RE: MARLBORO BRF 010-1(43) CONTRACTOR EROSION PREVENTION AND SEDIMENT CONTROL PLAN

VTrans has completed its review of the Contractor Erosion Prevention and Sediment Control (EPSC) Plan. Please address the following concerns and resubmit the EPSC Plan.

RESOURCE IMPACT SHEET

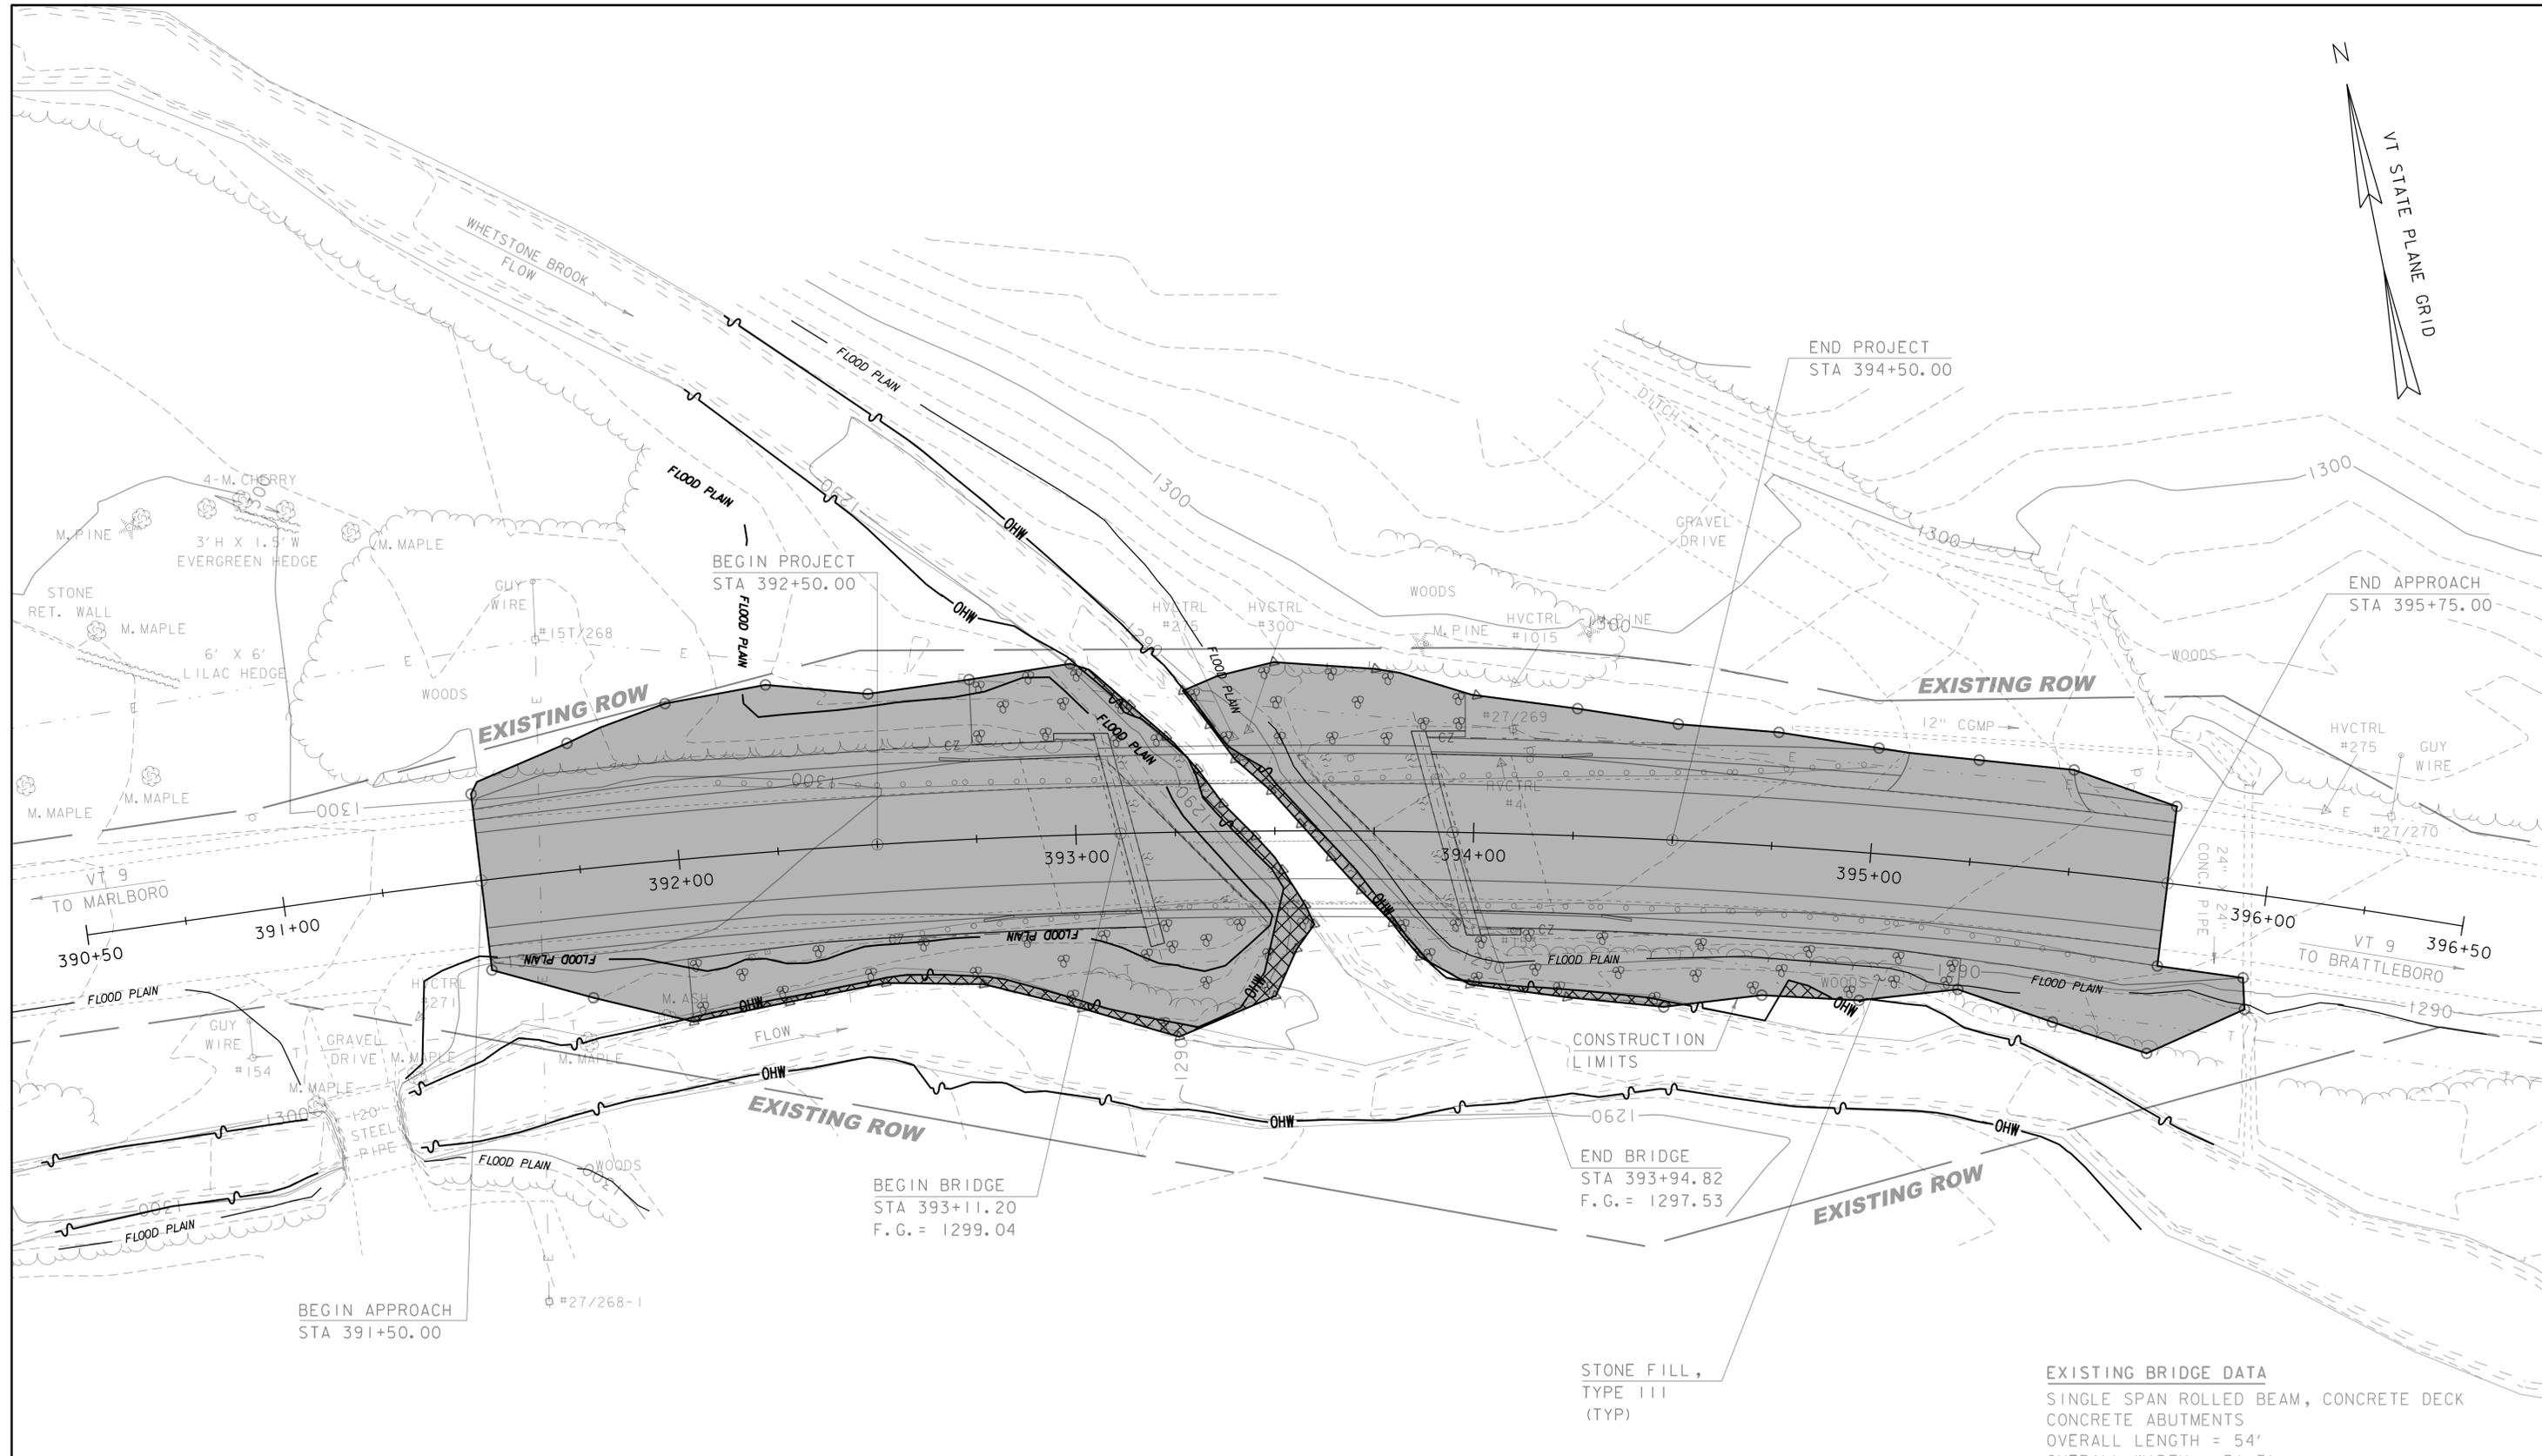
The project as contracted was estimated to disturb 0.68 acres of earth. Attached with this letter is the plan sheet showing the Contract estimated area. Your proposed footprint appears to be outside the contracted limits. Please calculate and disclose the additional area of disturbance.
